MANDATORY SERVICE BULLETIN

NUMBER: SB-028 REVISION: 01 **DATE:** June 7, 2013

SUBJECT: AFT FUSELAGE RIVET INSPECTION AND DOUBLER INSTALLATION

KODIAK 100 Series Aircraft Serial Numbers: 100-0001 through 100-0036

Figure 4-1: Inspection Area

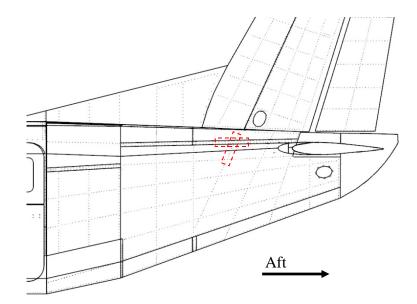
Visually inspect the exterior of the aircraft indicated in Figure 4-1, on both left and right sides, for skin damage including:

- 1. Rivet heads that are pulled sharply into skin
- 2. Cracking around rivet holes.

If skin damage is present, contact Quest Aircraft Company for repair instructions.

Figure 5-1: Remove Rivets

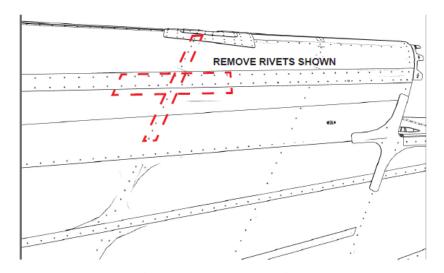
Using acceptable industry practices, as found in FAA Advisor Circular AC 43.13-1B, remove the rivets that attach the skin to the frame as shown in **Figure 5-1**.

It may be necessary to remove more rivets than shown in **Figure 5.1** to loosen skin and install the doubler as described in **Section 5.3**. Ensure that skin is loosened enough that doubler can be inserted without excessive force that would result in loss of corrosion protection on the doubler or the skin.

- 1. Visually inspect for cracks or severe dimpling at the empty rivet holes and the area under the rivet head in the area indicated in **Figure 5-1**.
- 2. If skin damage is present, contact Quest Aircraft Company for repair instructions.

Figure 5-2: Doubler (P/N 100-240-4057)

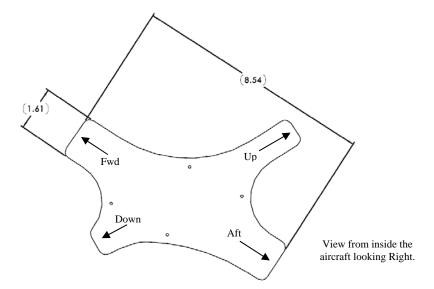
1. Position the doublers (P/N 100-240-4057) as shown in **Figure 5-2** and **Figure 5-4**.

2. Using the existing holes in the skin as a guide, drill two pilot holes through the positioned doubler (P/N 100-240-4057).

Figure 5-3: Interior Gap Measurement

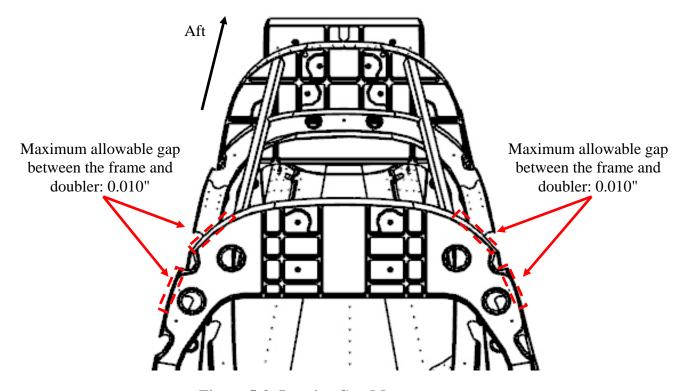
- 3. Install clekos, in the pilot holes.
- 4. With the doubler held in position, drill the remaining holes and cleko as holes are drilled.
- 5. Back drill four (4) holes in the inside corners of doubler (P/N 100-240-4057), to a hole size for a (P/N MS20470AD-4) rivet (circled in **Figure 5-4**).
- 6. Remove any drill debris.
- 7. Inspect the gap between the skin and the frame.
 - a. Ensure that no debris has accumulated in the gap.
 - b. Ensure the gap does not exceed 0.010" (**Figure 5-3**).

8. If the gap exceeds 0.010", install tapered shims at the end of the uppermost, fwd and aft fingers of the doubler as needed to fill gaps between the skin and associated frame such that there are no gaps greater than 0.010" before installing rivets.

If shim installation is required, use 2024-T3 ALCLAD sheet and round corners with minimum radius of .25" ±.060". Maximum allowable thickness of shims is 0.032". If shims need to be thicker than 0.032", contact Quest Aircraft.

Figure 5-4: Doubler and Rivet Installation

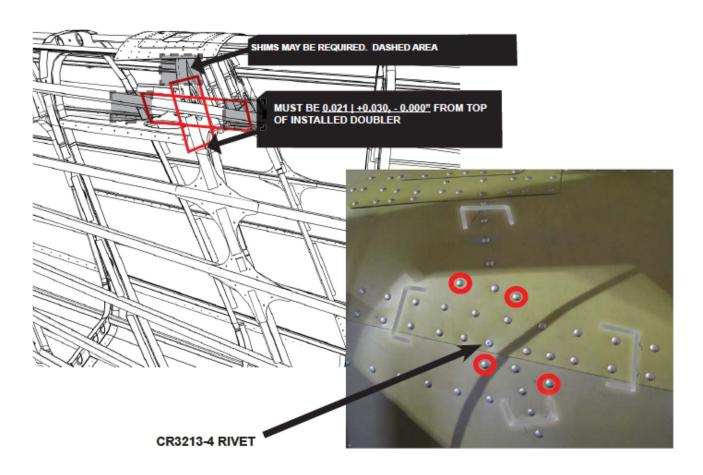
All rivets are nominally (P/N MS20470AD-4), except as shown in **Figure 5-4**, which is a (P/N CR3213-4, Cherry Max Rivet) for ease of installation. If a rivet hole becomes enlarged, deformed, or otherwise damaged, corrective action shall be taken per the guidance found in AC 43.13-1B, to ensure proper edge distance and drill or ream the hole for the next larger rivet size.

- 9. Install rivets.
- 10. Spot prime and touch up paint per AC 43.13-1B.
